STAFF REPORT

RE: **700 Truman Avenue #TP2022-0024**
(Final Landscape Plan Review)

FROM: Karen DeMaria, City of Key West Urban Forestry Manager

LANDSCAPE PLAN FOR DEVELOPMENT & TREE COMMISSION APPROVAL

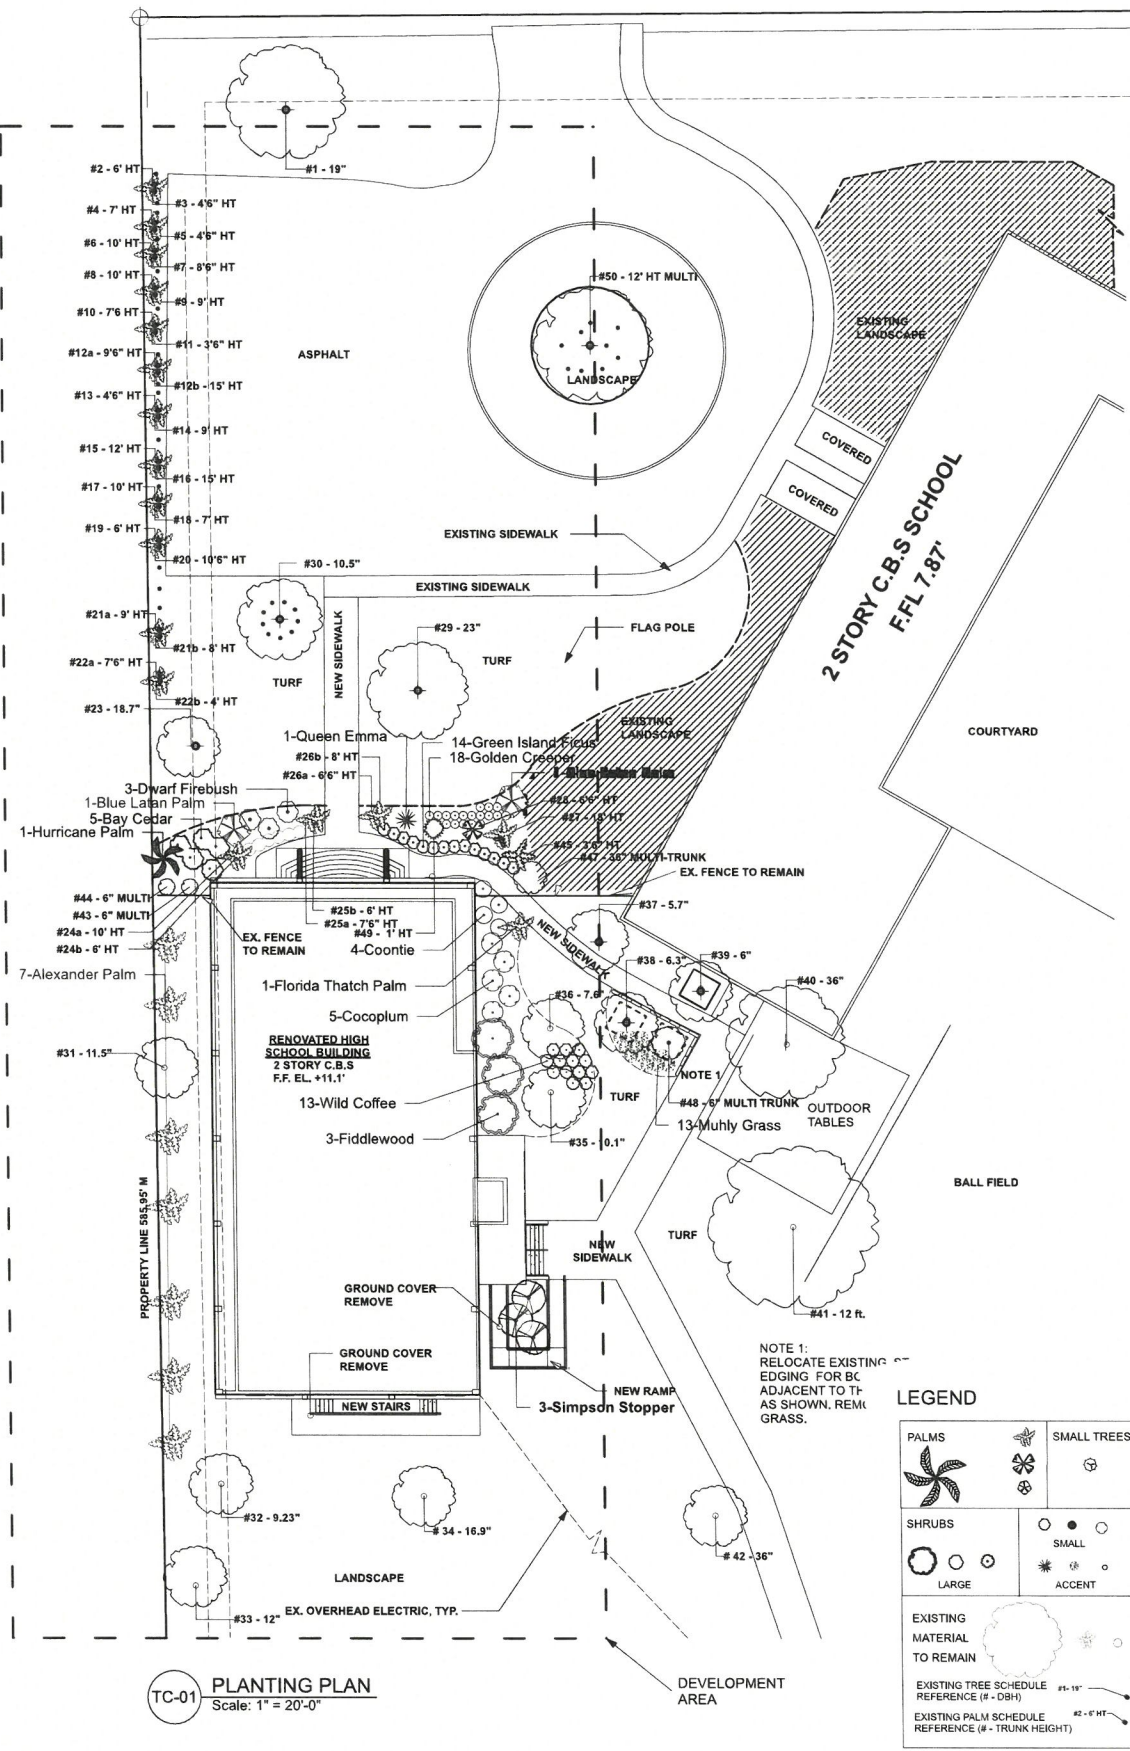
I had a meeting with Bill Horn about this a few weeks ago. I would look at the immediate area surrounding the auditorium for the review, the impact area of the proposed development and staging. Of primary interest are the existing trees around that area and some proposed buffer landscaping with the adjoining neighbors.
Sincerely,
Karen

THE PROPOSED DEVELOPMENT IS TO AN EXISTING BUILDING LOCATED ON THE BASILICA OF KEY WEST CAMPUS. THIS SITE IS HEAVILY VEGETATED WITH MANY SPECIMEN TREES AND PALMS. THE RENOVATION TO THE EXISTING AUDITORIUM WILL NOT IMPACT ANY EXISTING TREES OR PALMS. TREE PROTECTION ZONES SHALL BE INSTALLED, FOUNDATION PLANTINGS ADDED AND SCREENING INSTALLED ON THE NW BOUNDARY AS SHOWN PER THE CITY URBAN FORESTRY MANAGER' DIRECTION.
